# Office Action Summary

This is the first office action for application number 10/642,818, Method for Forming a Hanger for a Chain Link Fence, filed on August 19, 2003.

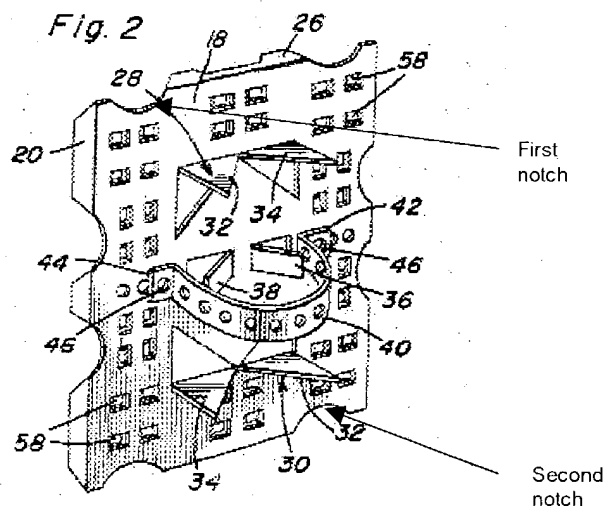
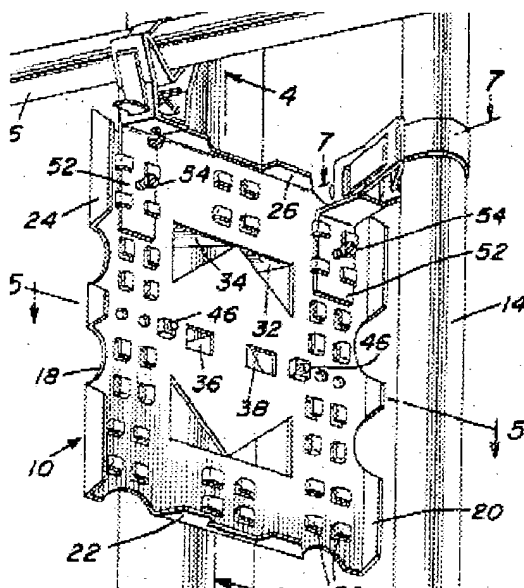
Menser '505 discloses a hook apparatus (above) comprising a first vertically disposed element (18,20) having two oppositely located end portions (right and left side, respectively), a second vertically disposed element (24) integral with the first element and extending from the top one (inherently the "top" depending upon some user's

wherein a flat fold portion (18) connects the first and second elements when the first and second elements are in their folded disposition, the fold portion being disposed perpendicular relative to a vertical reference and perpendicular to both the first and second elements;

wherein the flat fold portion has opposing staggered notches (above) on the anterior side edge of said flat fold portion;

wherein the staggered notches have a first notch (above) centered a distance from the union of the first element and the flat fold portion and second notch (above) centered a distance from the union of the second element and the flat fold portion, both notches having an internal radius;

However, Menser '505 fails to specifically teach the first and second elements to be separated by approximately 1.125 inches in their folded position, the first notch to be centered approximately .431 inches from the union of the first element and the flat fold

portion, the second notch to be centered approximately .431 inches from the union of the second element and the flat fold portion; both notches to have an internal radius of .156 inches, and the elements to have a generally constant width of approximately 2.20 inches. It would have been obvious to one of ordinary skill in the art at the time the invention was made to have constructed the previously mentioned features of any number of various dimensions, including those as specifically recited because doing so is considered a design choice and hence not considered patentable since the applicant has not specifically recited in the originally filed specification why such a dimension is critical to the invention or produces any unexpected result. See *In re Kuhle*, 526 F.2d 553, 188, USPQ 7 (CCPA 1975).
